ENGINE - MAIN GEARBOX ASSEMBLY - INCORPORATE A LAYSHAFT EXTENSION GEAR AND PMA DRIVE GEAR WITH INCREASED FACE WIDTH - CATEGORY CODE 4 - MOD.ENG-72-0070

V2500-ENG-72-0070

Remove and Install the angle gearbox support
Fig.1

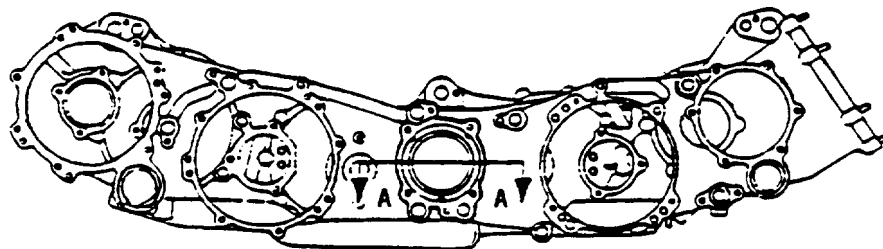
- (a) Remove the 4W0002 nuts (16 off) 4W1249 bolt (1 off) and MS9321-10 washers (17 off)
- (b) Remove the 4B0062 angle gearbox support.

Refer to figure 1

| (a) Install the new AS3209-165 packing, AS3209-151 packing and AS3209-120 packing on the angle gearbox support. | Refer to figure 1 |

Remove and install the PMA drive housing and the layshaft extension gear
Fig.2

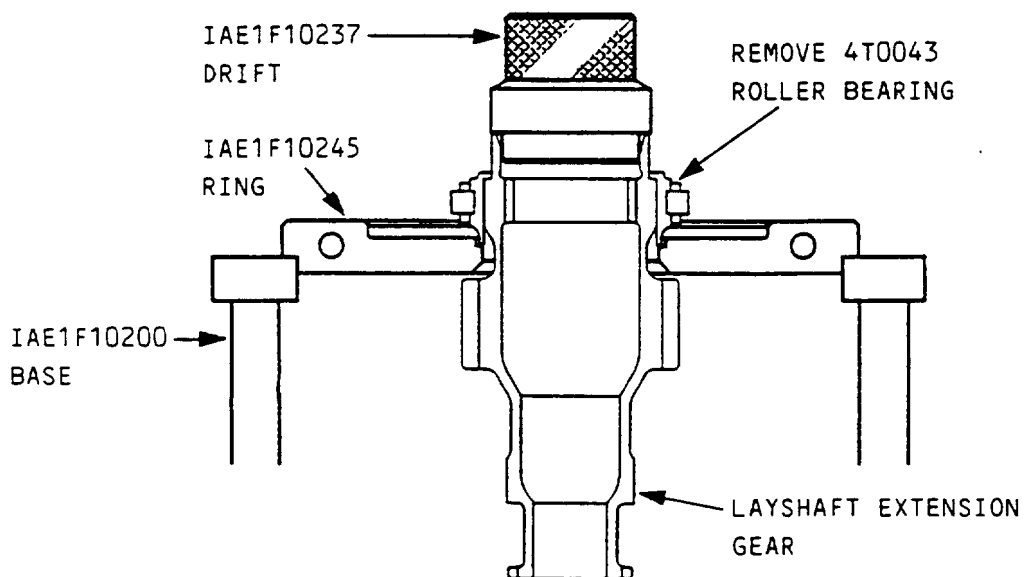
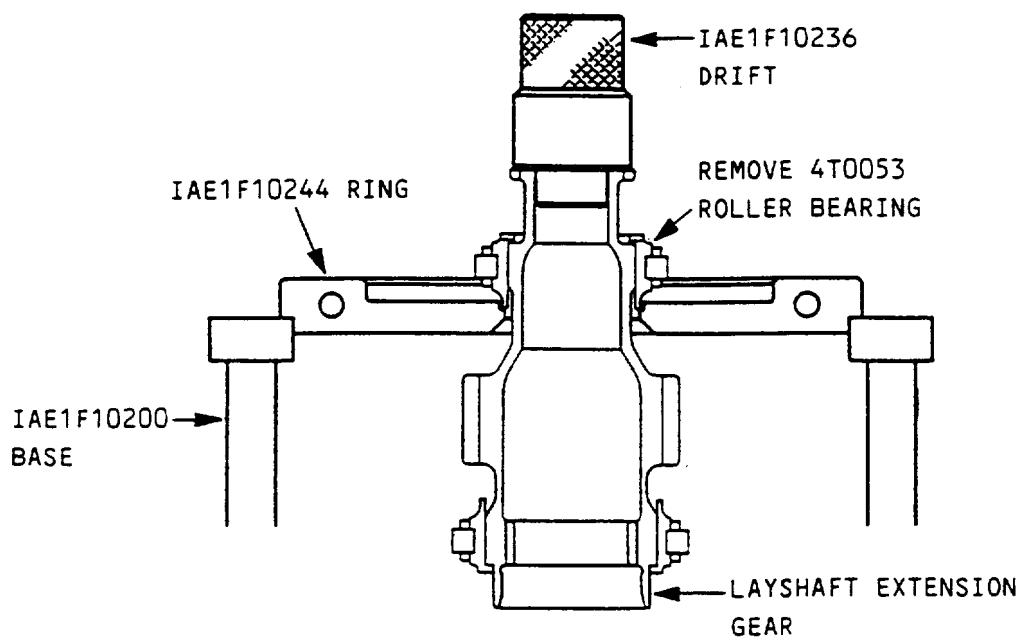
- (d) Remove the two 4W0002 nuts and MS9321-10 washers and remove the 4B0292 (or 4B0143 pre SBE 72-0048) PMA drive housing

- (g) Remove the 4P0175 or 4P0294 layshaft extension gear from the gearbox.

- (h) Unlock and remove the three AS3100-10 bolts and 4T0210 washers.

- (j) Remove the three 4W0002 nuts and remove the outer race of the 4T0053 roller bearing from the 4B0292 (or 4B0143 pre SBE 72-0048) PMA drive housing.

| (a) Install the outer race of the 4T0043 roller bearing on the gearbox. | Refer to figure 2 |
| (b) Install the three new 4T0210 washers and AS3100-10 bolts. Torque to 85 to 95 lbfin (0,9 to 1,07 mdaN). | |

- (d) Install the outer race of the 4T0053 roller bearing on the PMA drive housing. Refer to figure 2
- (e) Install the three 4W0002 nuts. Torque to 85 to 95 lbfin (0,9 to 1,07 mdaN).
- (5) Install the 4B0285 or 4P0287 layshaft extension gear on the gearbox.

- (a) Install the layshaft extension gear in to the gearbox. Refer to figure 2
- (b) Engage the gear with the adjacent oil scavenge pump gear drive.
- (c) Install the starter idler gear in to the gearbox. Refer to figure 1

- (d) Engage the gear with the adjacent drive gears.
- (6) Install the 4B0292 PMA drive housing on the gearbox.
- Procedure
- Supplementary Information
- (a) Install the new AS3209-154 packing on the housing. Refer to figure 2

Disassemble of the layshaft extension gear
Fig.3

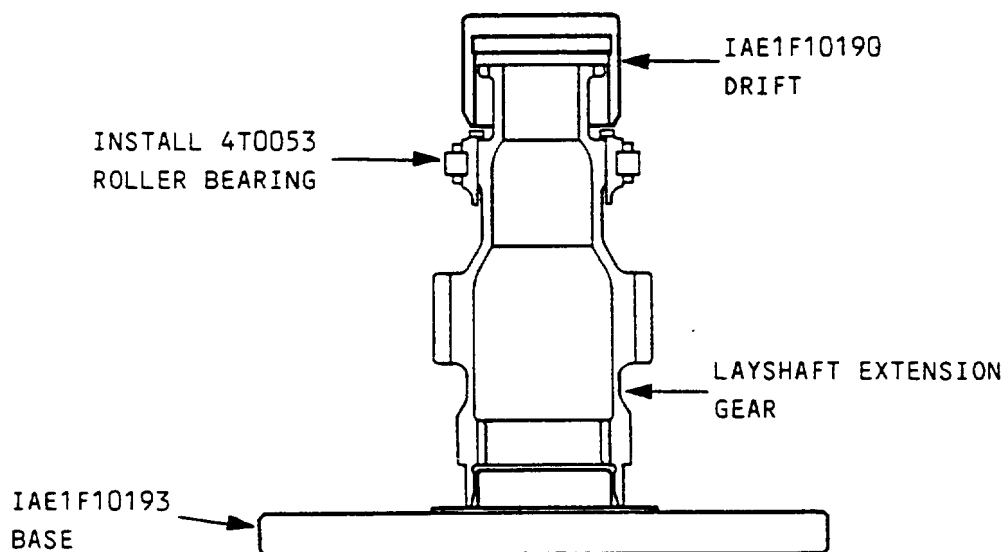
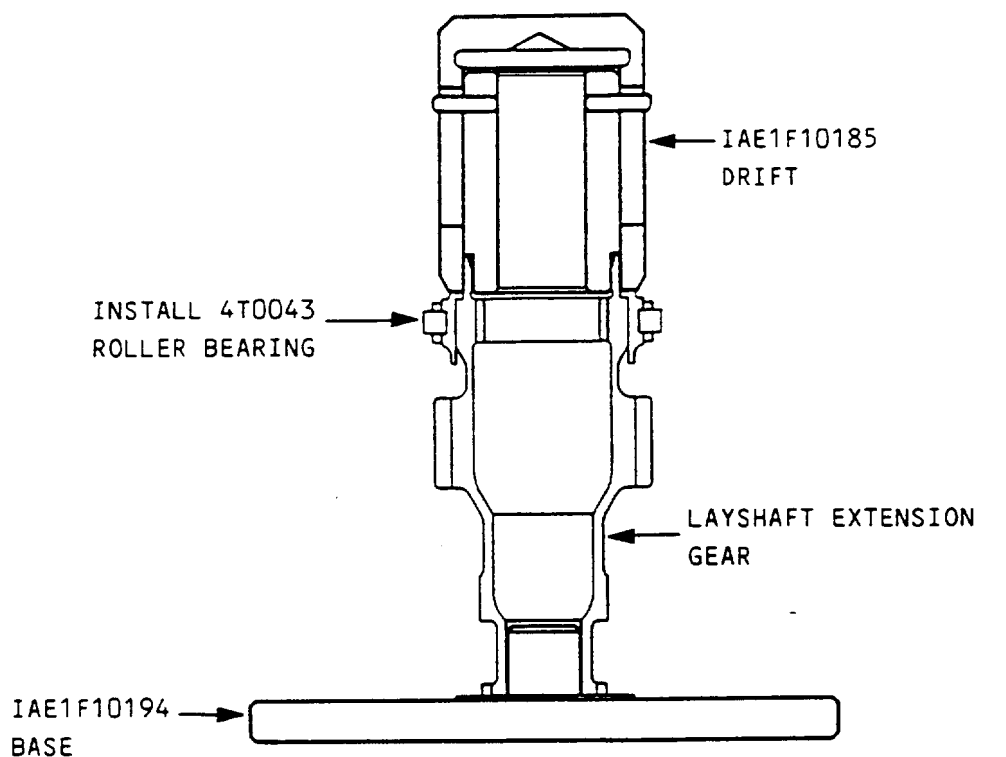
- (a) Remove the inner race of the 4T0053 and 4T0043 roller bearings

Refer to figure 3.
Use the IAE1F10200 base IAE1F10244 ring, IAE1F10245 ring, IAE1F10236 drift and IAE1F10237 drift.

Assemble the layshaft extension gear
Fig.4

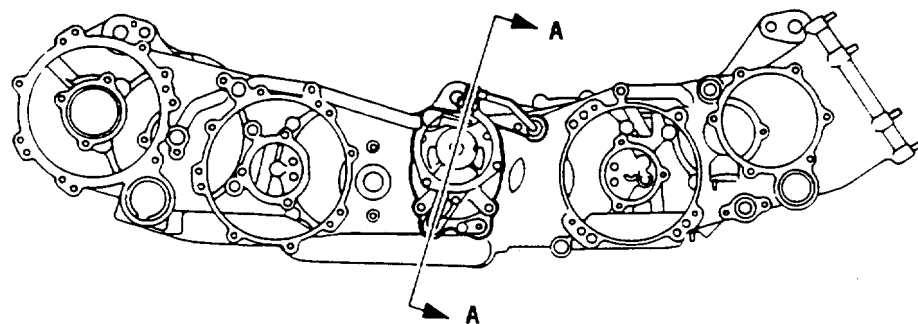
| (a) Increase the temperature of the inner race of the 4T0053 and 4T0043 roller bearing to 250 deg F (121 deg C) maximum. | Refer to figure 4
| (b) Install the inner race of the roller bearing on the gear. | Refer to figure 4

Use IAE1F10193 base, IAE1F10194 base, IAE1F10190 drift and IAE1F10185 drift. |

| (c) Apply a load of 3372 lbf (1500 N) on the 4T0053 roller bearing and a load of 4047 lbf (1800 N) on the 4T0043 roller bearing | Use an arbor press or equivalent |

PMA drive gear assembly (Before alterations)
Fig.5

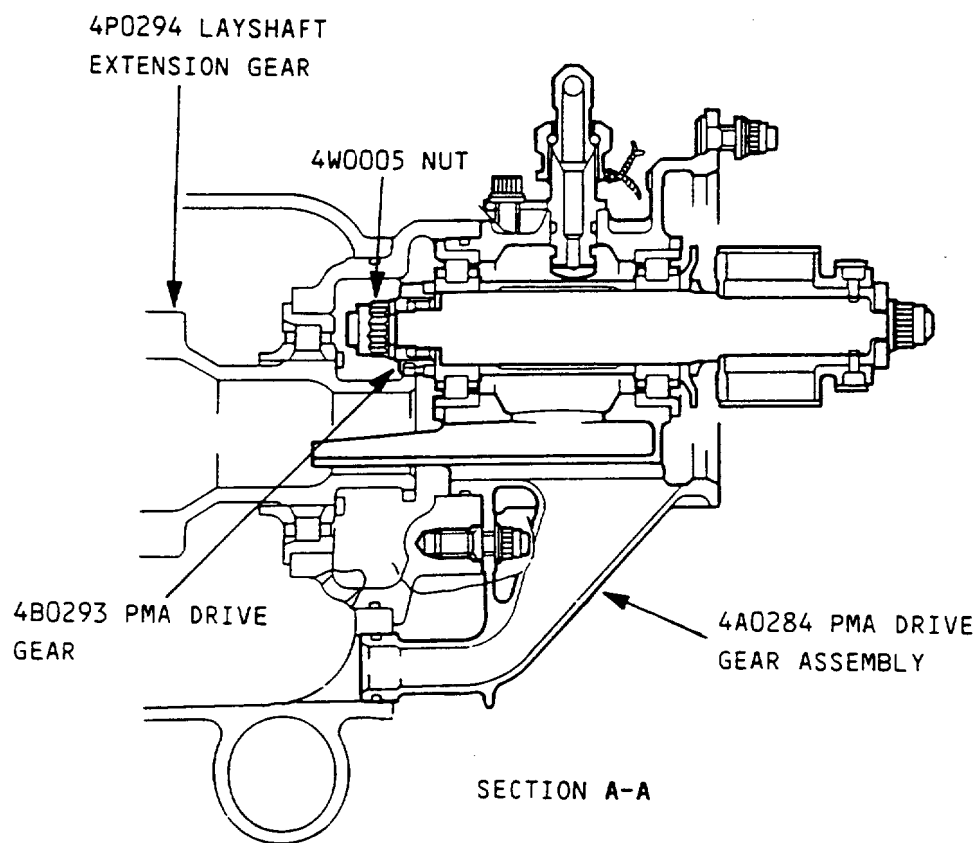
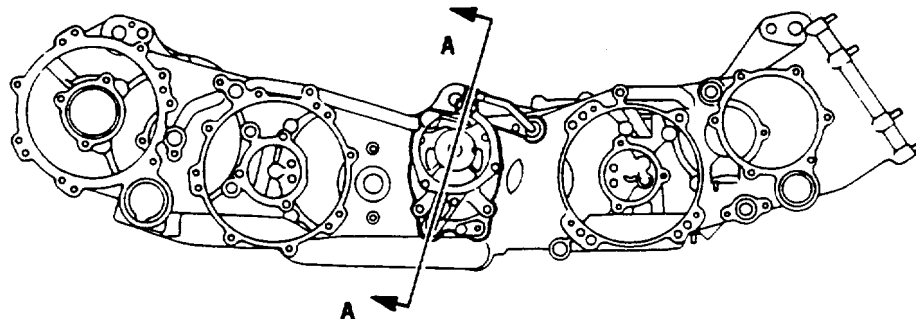
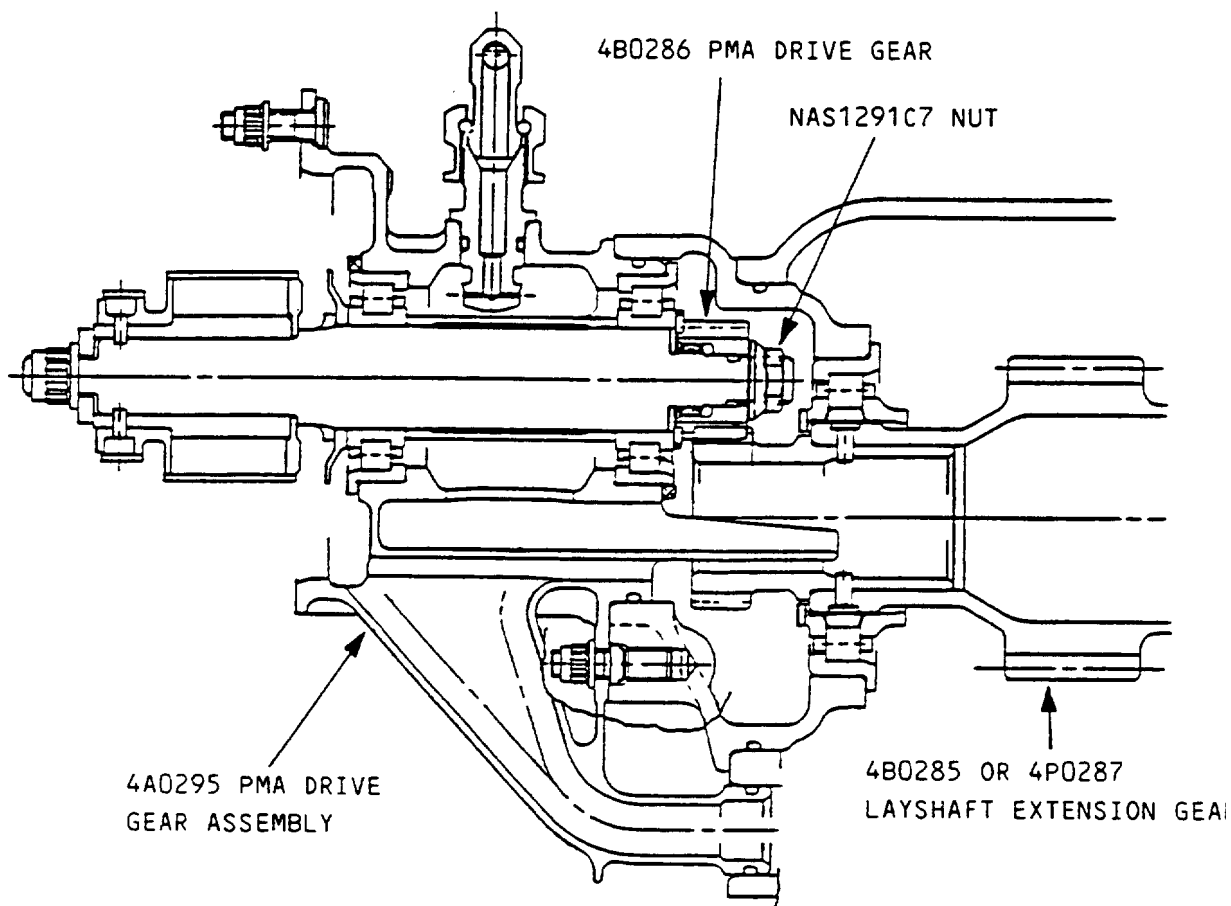
| (c) Discard 4B0293 (or 4B0147 pre SBE 72-0048) drive gear and the 4W0005 nut. | Refer to figure 5 |

- (b) Install the new 4B0286 drive gear and NAS1291C7 nut.

CAUTION: THE NEW NAS1291C7 NUT MUST BE TORQUED TO 309 TO 395 lbfin (3,5 to 4,0 mdaN) INSTEAD OF 450 to 500 lbfin (5,08 to 5,65 mdaN) OF THE OLD 4W0005 NUT.
